MEMORANDUM

TO: MEMBERS OF THE PLANNING COMMISSION
THRU: BARBARA MCBETH, *A/CP*, CITY PLANNER
FROM: SRI RAVALI KOMARAGIRI, PLANNER
SUBJECT: JSP 18-74 SLI MEDICAL OFFICE BUILDING
DATE: OCTOBER 25, 2019

Re: Plan Review Center Report
Planning Review, dated 10/1/19
SLI Medical Office
42350 Grand River Avenue
Novi, MI 48375
JSP 18-74

SHEET NAME
TRUCK TURNING PLAN

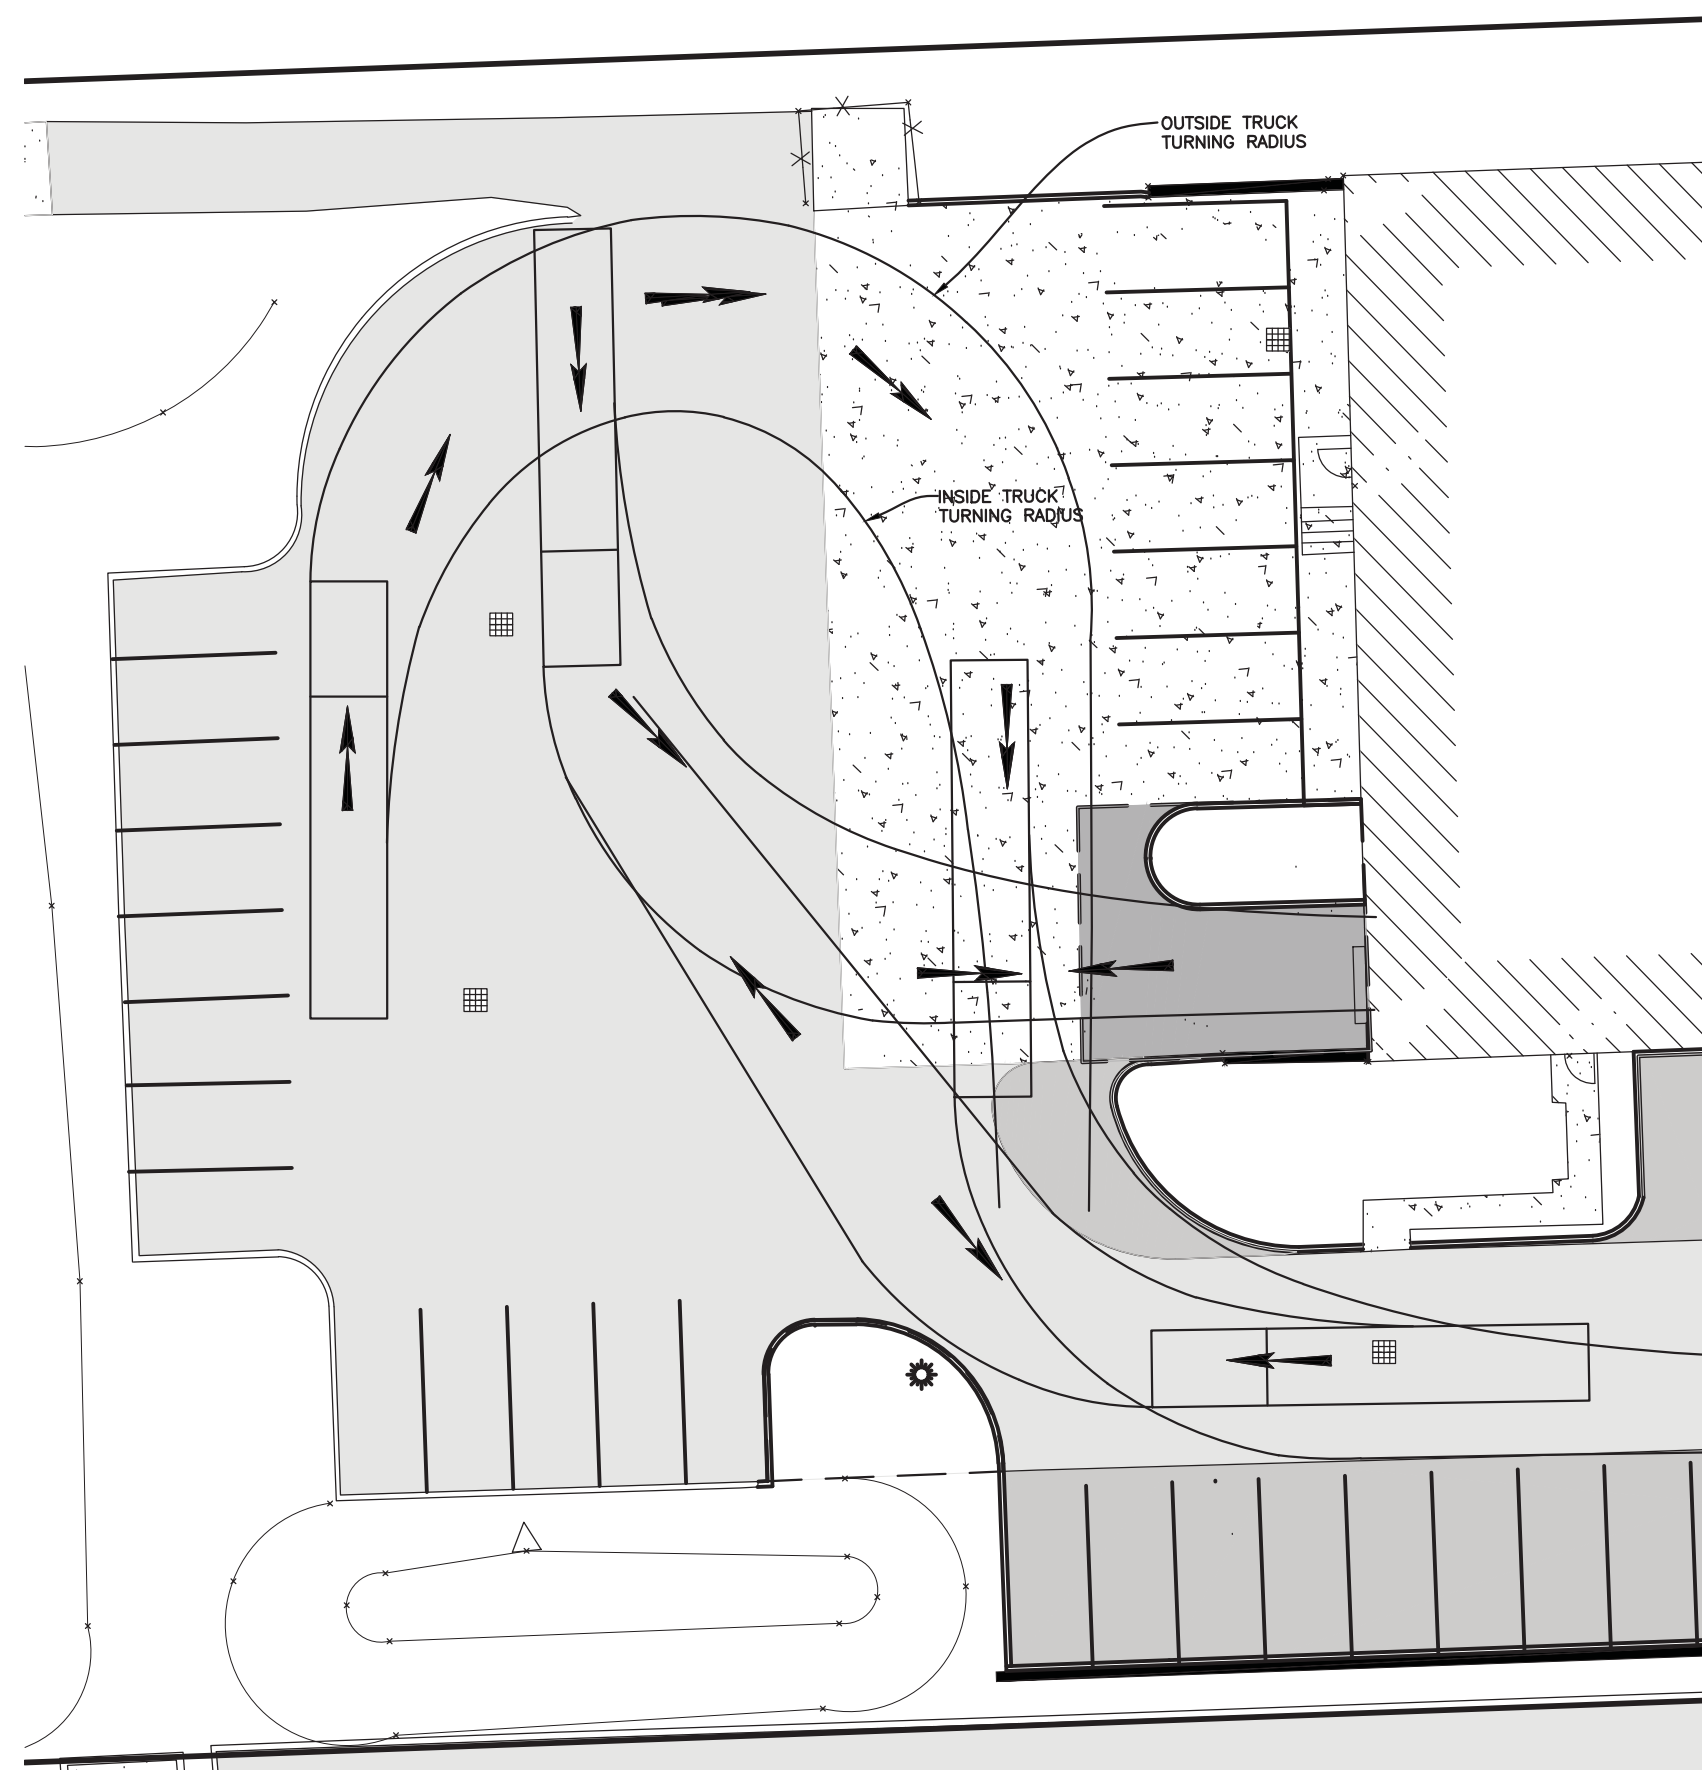
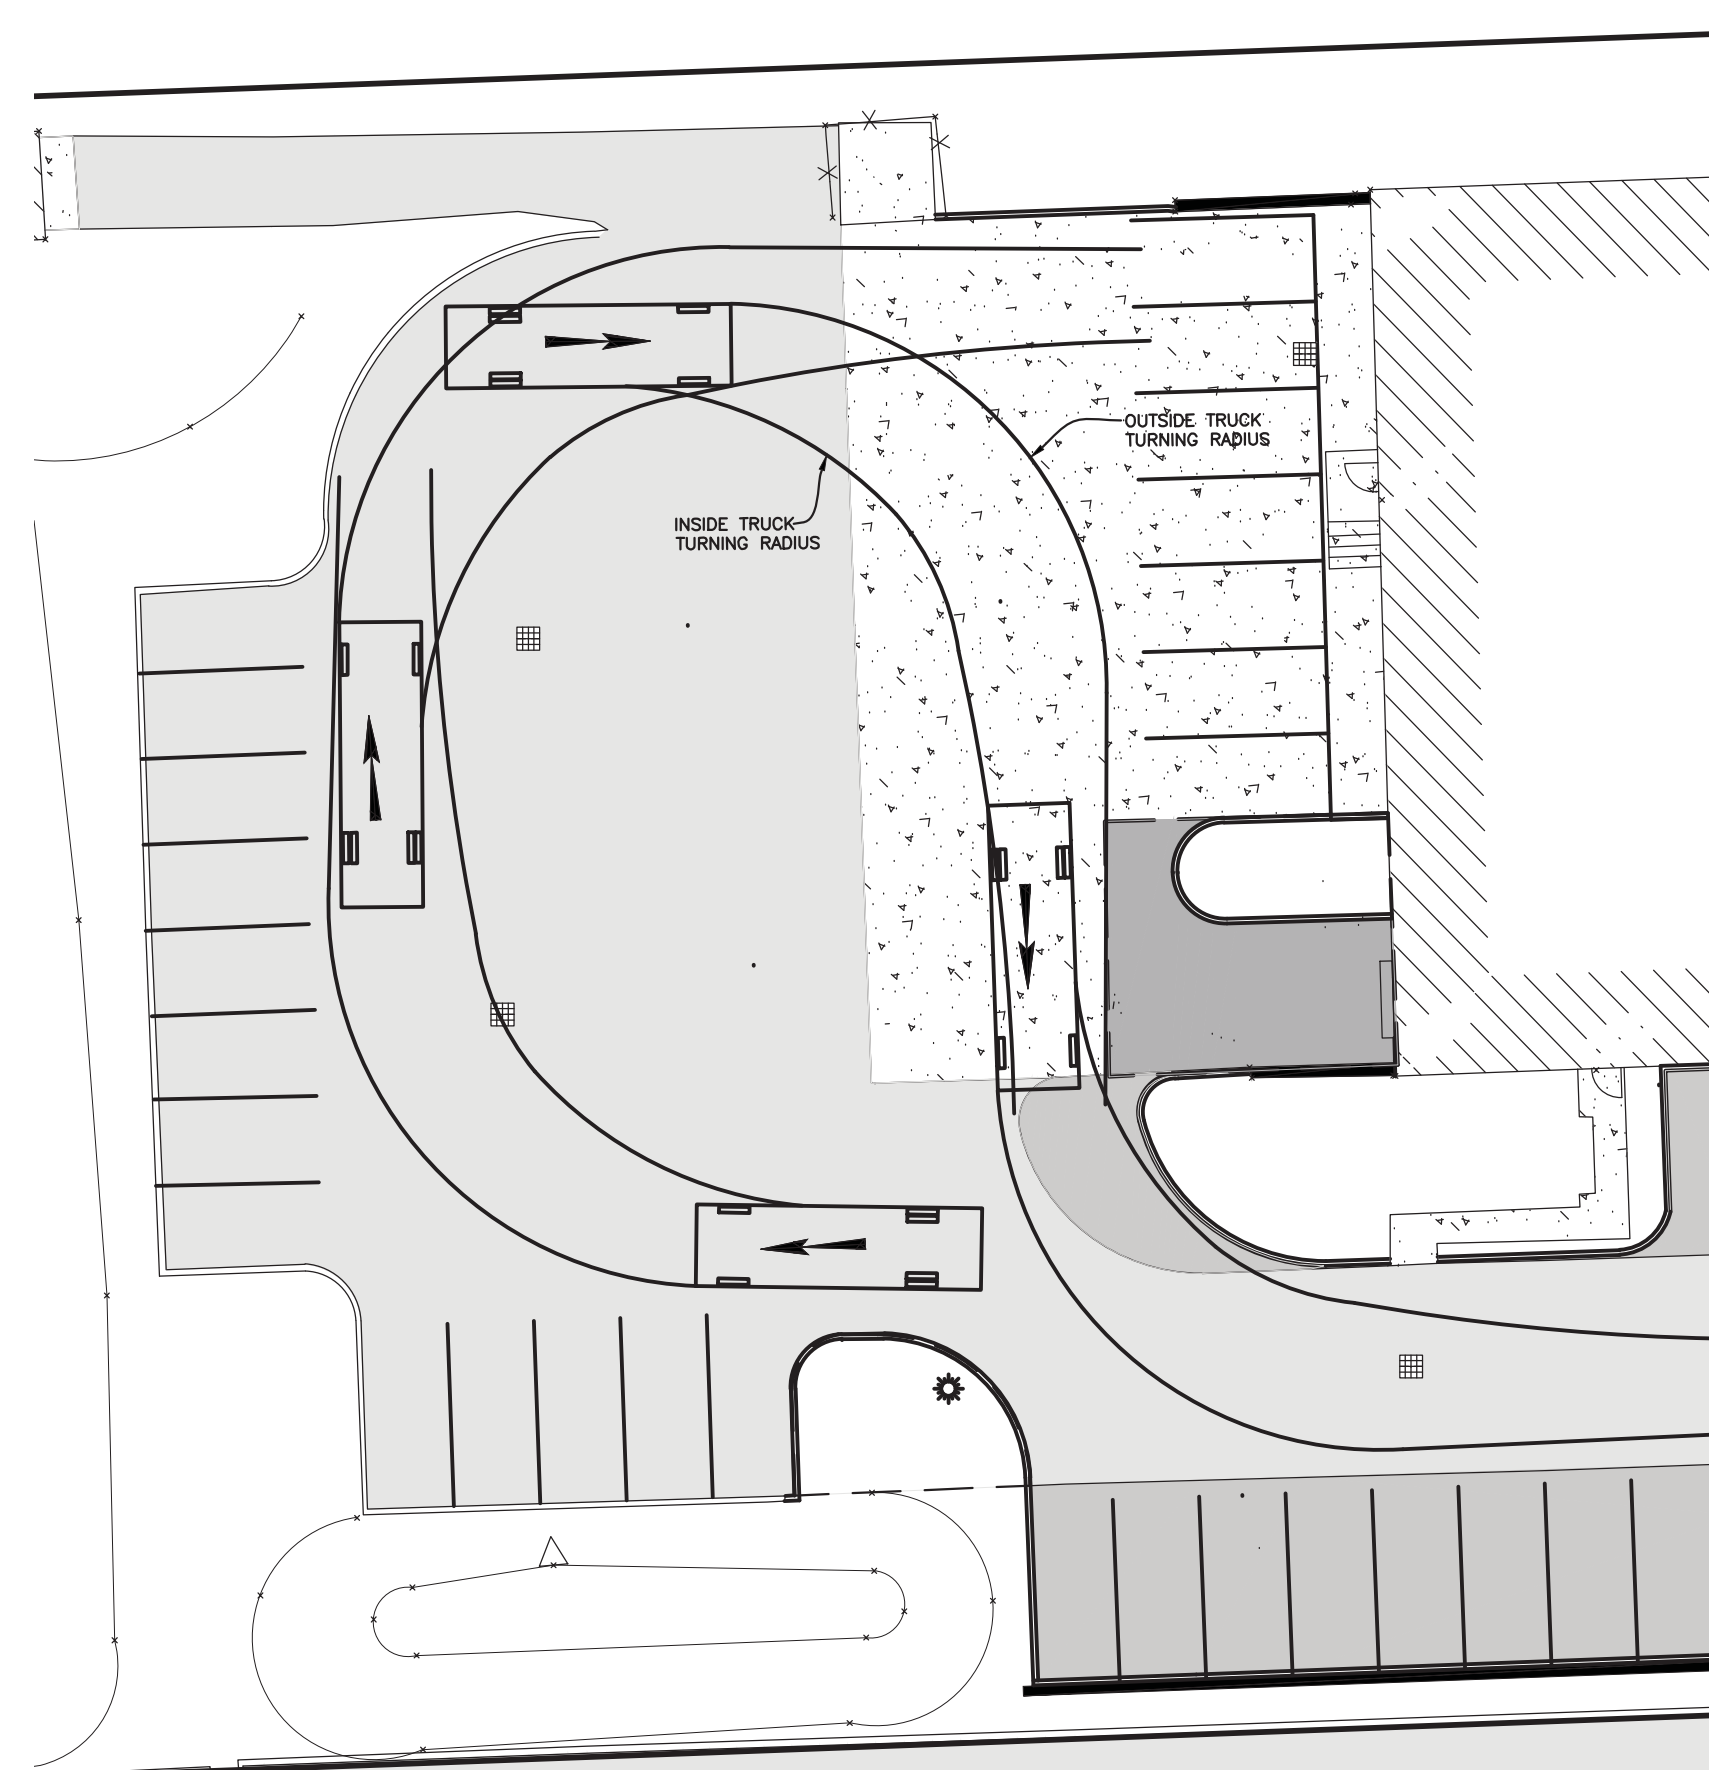
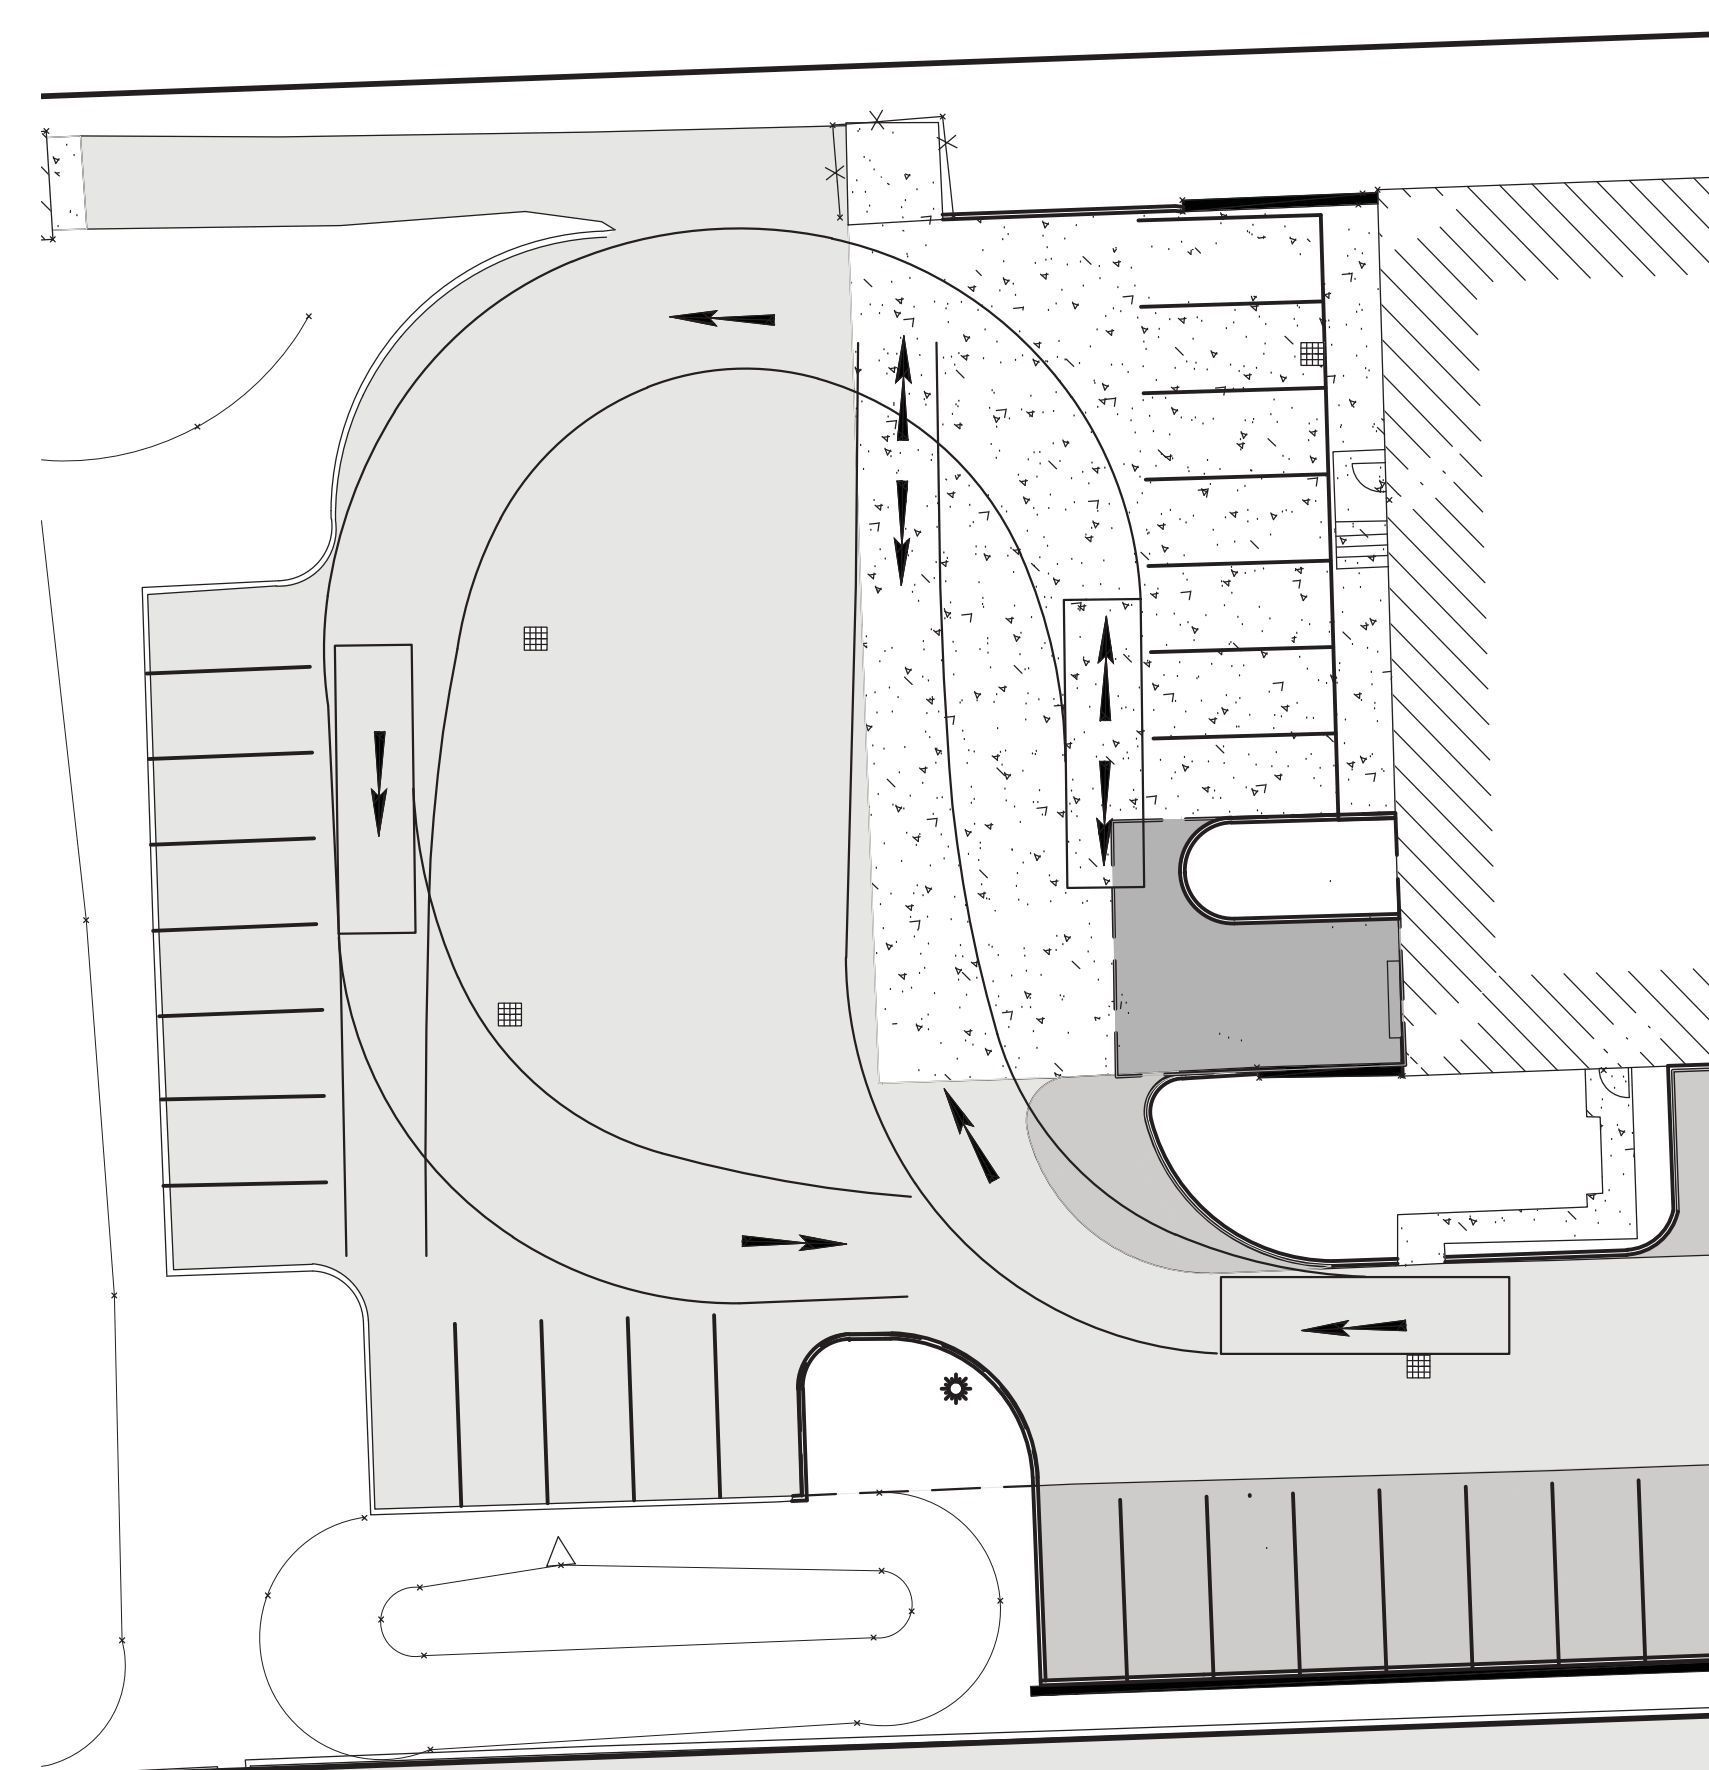
1. The applicant shall provide a truck circulation diagram as noted in the Traffic review letter at the time of final site plan.

1. Truck turning movement patterns should be provided to show that the trash receptacle locations do not interfere with the use of the adjacent proposed parking spaces.

A fire truck turning template, a dumpster/garbage truck turning template, and a WB-40 truck turning template are shown on sheet 5 of the revised plans.

A fire truck turning template, a dumpster/garbage truck turning template, and a WB-40 truck turning template are shown on sheet 5 of the revised plans.
